**SAFETY EVALUATION REPORT
RENEWAL OF LICENSE SNM-1107 FOR
WESTINGHOUSE ELECTRIC COMPANY LLC, HOPKINS, SOUTH CAROLINA
DOCKET NUMBER 70-1151**

Enclosure 2

Figure 2.1 CFFF Organization

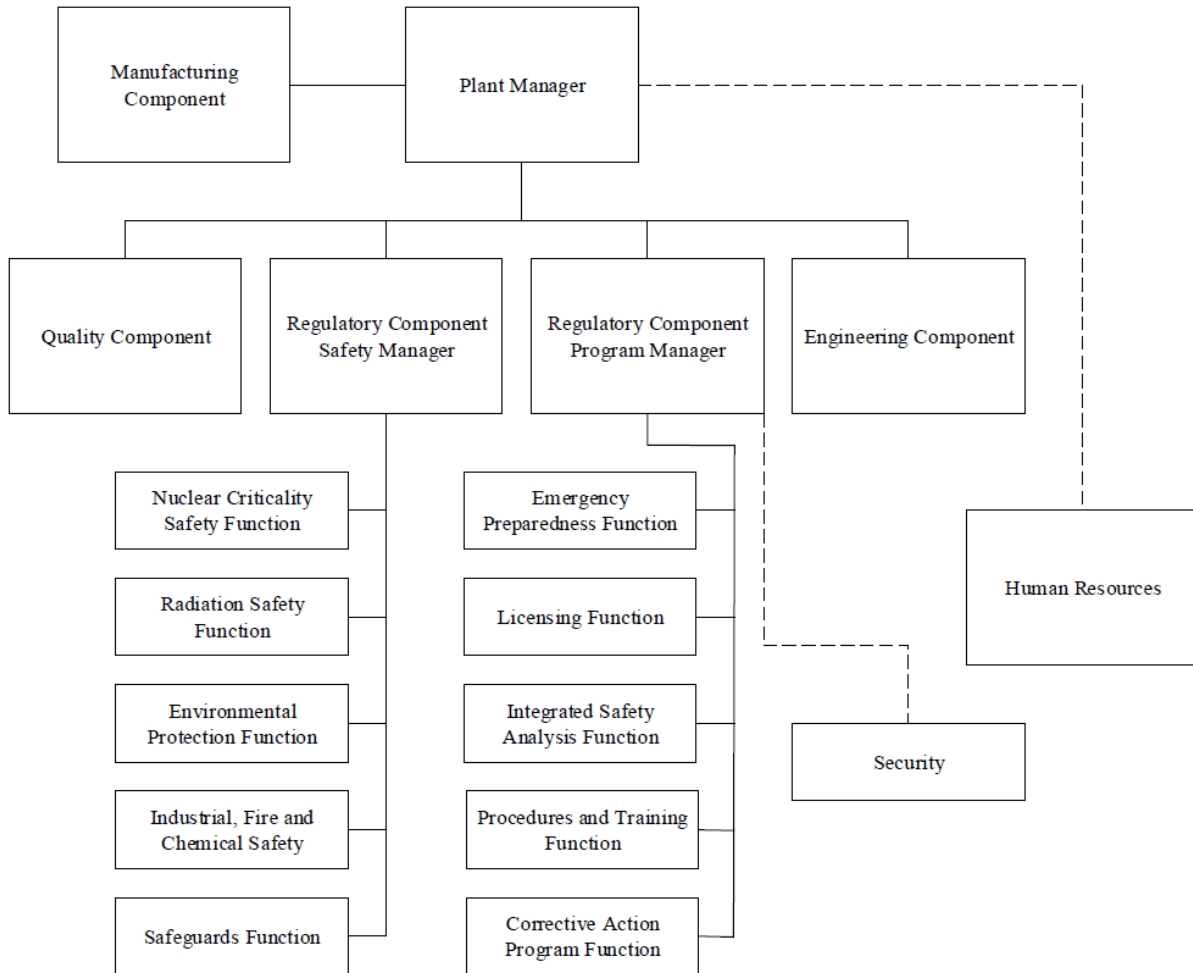
The LRA provided a defined organization hierarchy which includes the plant manager, component managers, and the first-line supervisor. Each level of management has defined roles with specific areas of responsibility, as described in the LRA. In addition, the regulatory component provided the safety, safeguards, and regulatory functions which are maintained independently of the manufacturing function to avoid conflict of interest. The organizational hierarchy described in the LRA is consistent with the acceptance criteria provided in NUREG-1520, Rev. 1, Section 2.4.3, and therefore meets 10 CFR 70.22 and 10 CFR 70.23. Based on its review, the NRC staff finds WEC's organizational hierarchy acceptable.

As discussed in Section 2.1.1.3, “Position Accountability and Requirements,” of the LRA (WEC, 2019e), the CFFF has a formal organization with clearly delineated lines of authority, see Figure 2.1.
